June 12, 2023

**RE: V-FEE MENDHAM APARTMENTS LLC DEVELOPMENT APPLICATION
REVISED DOCUMENTS
84-90 MAIN STREET
BLOCK 801, LOT 20
MENDHAM BOROUGH, MORRIS COUNTY**

StreamStats Report

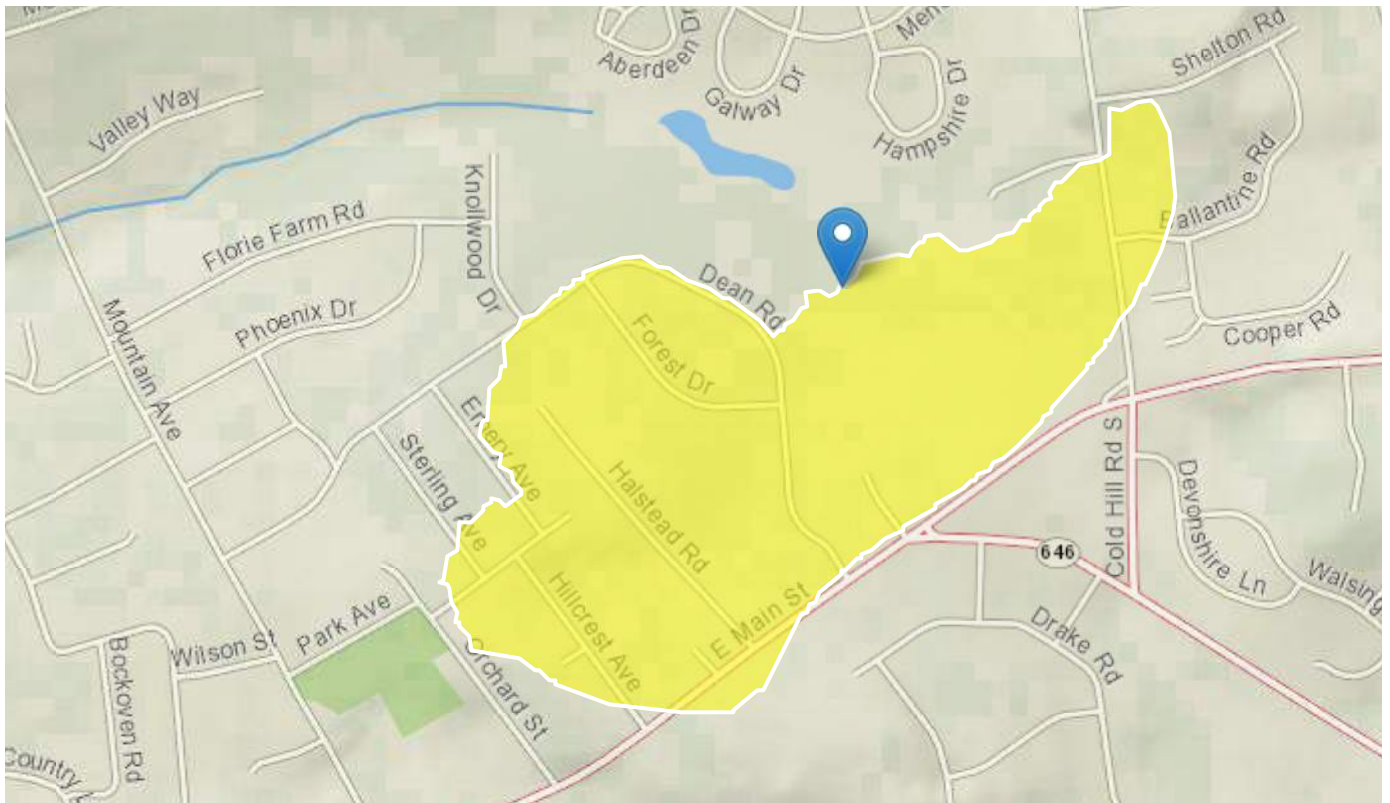
- b. We have run USGS StreamStats as a point of reference for the total drainage area to the stream at the site. The StreamStats report is provided as Attachment B which shows a drainage area of 173 acres, which is more than double the area of 75 acres presented in the Flood Hazard Area Study.

- c. The approximate method (Method 5) was analyzed for the site based on a drainage area of 173 acres in Watershed Management Area 8. The resulting flooding depth from Method 5 is 9 feet. However, the Flood Hazard Area Study indicates flooding depths of approximately 1 foot at the cross-sections at the site. This much of a discrepancy is unusual, and we recommend the applicant confirm that the method 6 calculations are accurate.
